A. **Beaufort Senior Apartments, PIN R122 029 000 0625 0000**, 1556 Salem Road.
Applicant: Michael Riley, Architect (23-02 DRB.5)

STAFF REPORT: 1556 Salem Road Site Plan/Senior Housing

Project Name: Beaufort Senior Apartments

Response to comments (8-11-2023)

PICNIC PAVILION DETAIL

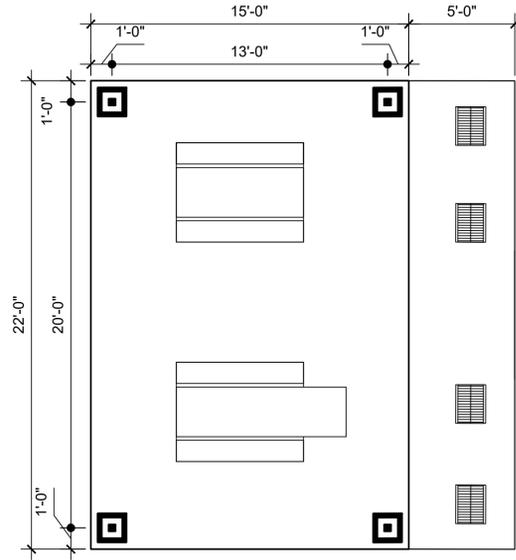
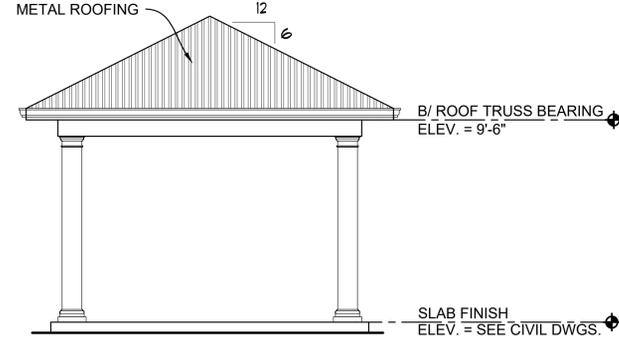
11. On picnic pavilion, staff recommends the applicant align the band beam with the column shafts below.

A1.7

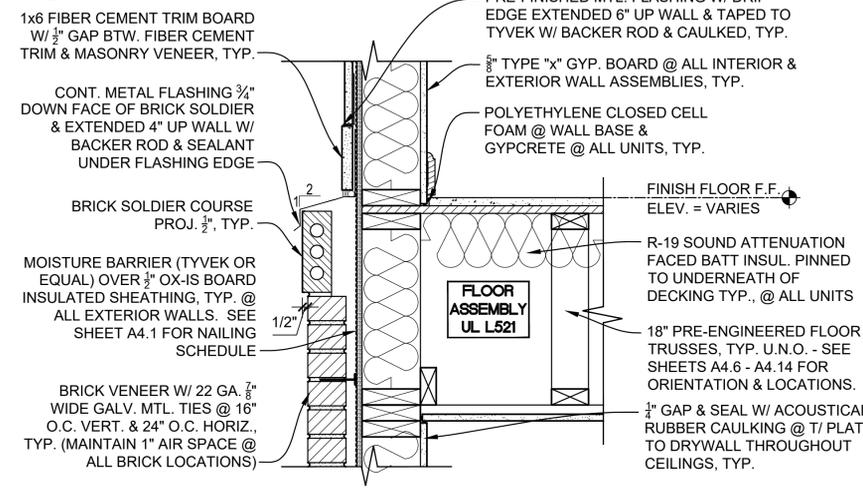
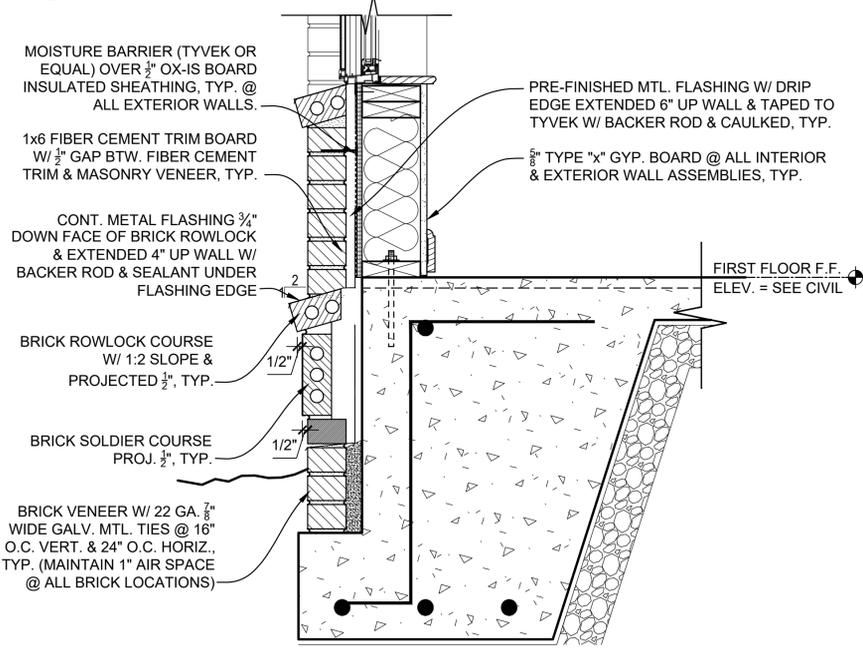
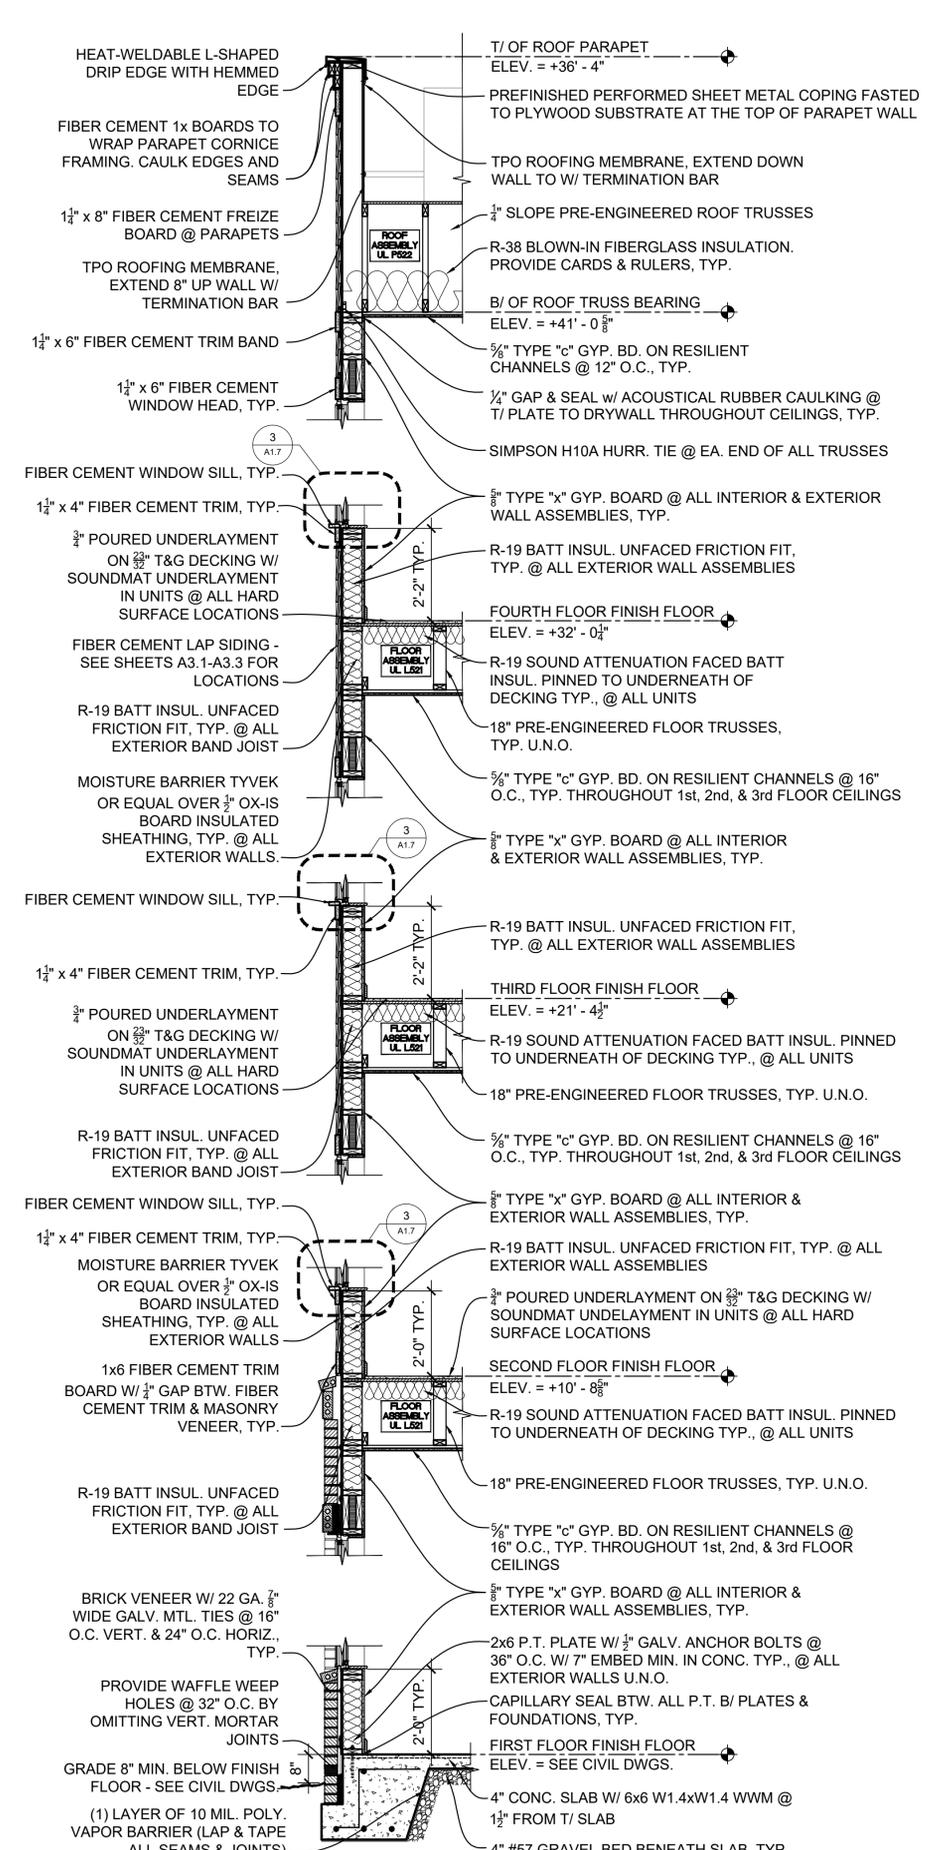
3. Staff recommends the applicant select SDL windows.
4. Detail 4 on sheet A1.7 illustrated metal tie plates on the wood timber support brackets. Staff recommends the applicant eliminate these visible tie plates and instead use concealed fasteners to fabricate these brackets.

6. Applicant to confirm that the parapet cap flashing is white per the colored elevation.
7. On sheet A1.7, the projecting windowsills do not appear to be sloped to drain. Applicant to confirm.

8. The larger scale wall section 1 on sheet A1.7 has detail callouts for the windowsills referencing detail 3 on sheet A1.7. However, this is not the correct reference and larger scale projecting windowsill details are missing from application.

- a. See sheet A1.8.
4. Applicant to provide necessary wall sections to understand material interactions and profiles (in addition to staff's comments, the board would like to understand the parapet conditions around the project).

- a. See detail #1 & #2 on sheet A1.7.
5. On sheet A3.1, applicant to consider expanding the porch at the commercial leasing office to cover the window (porch floor and roof).
